Re: Rapiscan AIT System Radiation Survey Reporting

Rapiscan systems	Secure 1000 Radiation Emission Measurement	FORM R-0646-1 (Single Pose)
----------------------------	---	--------------------------------

R-0646-1 Addendum (Documentation Errors)

Product Name	Secure 1000SP (Single Pose)
Serial Number	S50950006
Radiation Emission Measurement	Radiation Survey Dated: 04/29/2010
RSO Initials

1. In Beam Dose Measurement: Survey Table. 1

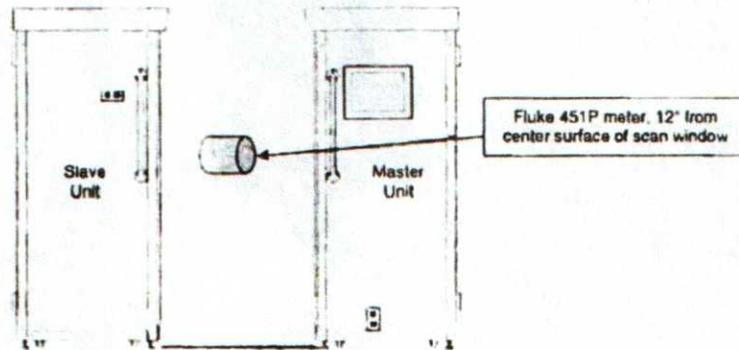
1. No value indicated for background radiation. Typical values range from 7uRem/hr to 13uRem/hr at sea level. Note: Absence of value has no adverse impact on calculations.
2. Technician indicated scan time as 7 seconds. Correct scan time is 3 seconds.
3. TABLE 1: Incorrect presentation of data in Column 3 for Measured Exposure. Indicated values are 29uR and 23uR. Corrected values are 2.9uR and 2.3uR. The values were corrected by technician when calculating Effective Dose.
4. TABLES 2 and 3: Incorrect presentation of data in Column 6 for Dose Equivalent. Indicated values are .18 uRem. The correct value should be 1.8 uRem.

The service technician should attend refresher training.

The corrected data indicates this system was operating within expected parameters. No re-survey is required for this system.
